WELL API NO. 30-025-22585
5. Indicate Type of Lease STATE <input checked="" type="checkbox"/> FEE <input type="checkbox"/>
6. State Oil & Gas Lease No. LG-6974-0003
7. Lease Name or Unit Agreement Name State 8 #001
8. Well Number 001
9. OGRID Number 162499
10. Pool name or Wildcat Vada Penn & East Lane Abo

SUNDRY NOTICES AND REPORTS ON WELLS
(DO NOT USE THIS FORM FOR PROPOSALS TO DRILL OR TO DEEPEN OR PLUG BACK TO A DIFFERENT RESERVOIR. USE "APPLICATION FOR PERMIT" (FORM C-101) FOR SUCH PROPOSALS.)

Proposed Plugging Procedures
Novy Oil & Gas Inc.
State 8 #1
30-025-22585

Novy Oil & Gas, Inc.
State 8 #1
API 30-025-22585
WBD Before PA

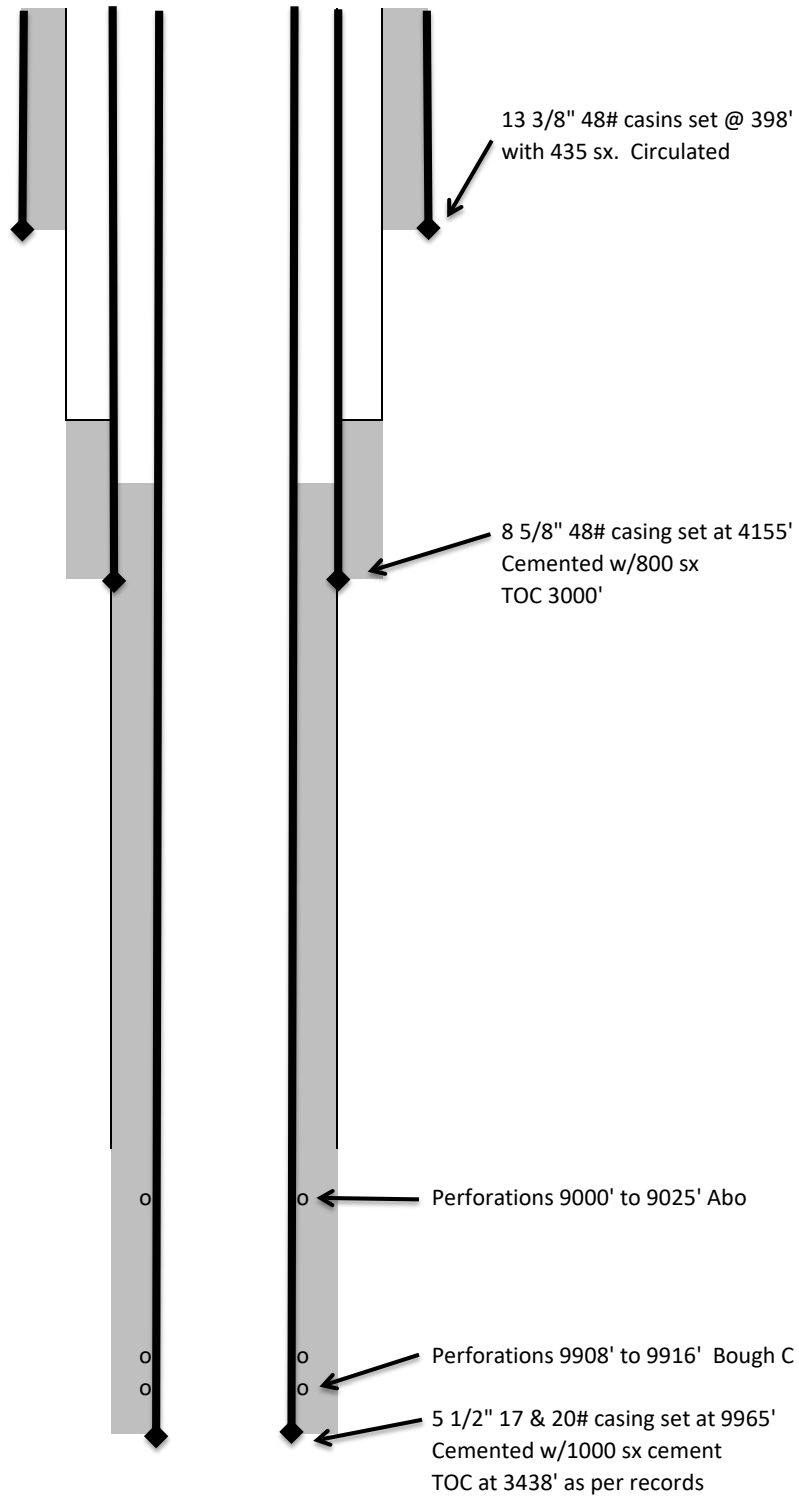
SEE CHANGES TO PLUGGING PROCEDURE

3. Set 5.5" CIBP over Abo perfs at 8920'. Tag with tubing and circulate MLF, test casing and spot 25 sx Class H cement on top of CIBP. **Run CBL and Bubble Test** **Spot 25 sx CI H cmt 7864' - 7620' - T Abo**

4. Spot 25 sx **C** at **7005'**. Top of Tubb
5. Spot 25 sx C at **5517'**. Top Glorieta
6. Spot 30 sx C at 4202'. Intermediate Shoe and top San Andres.
7. Perforate at **2814'** and squeeze with 75 sx cement. Tag above 2664'. Yates and Base of Salt.

8. Perforate at **2210'** and squeeze with 75 sx cement. Tag above 2060'. Top Salt.
9. Perforate at 448' and **circulate to surface in/out 5 1/2"x8 5/8" & 8 5/8" x 13 3/8"**.
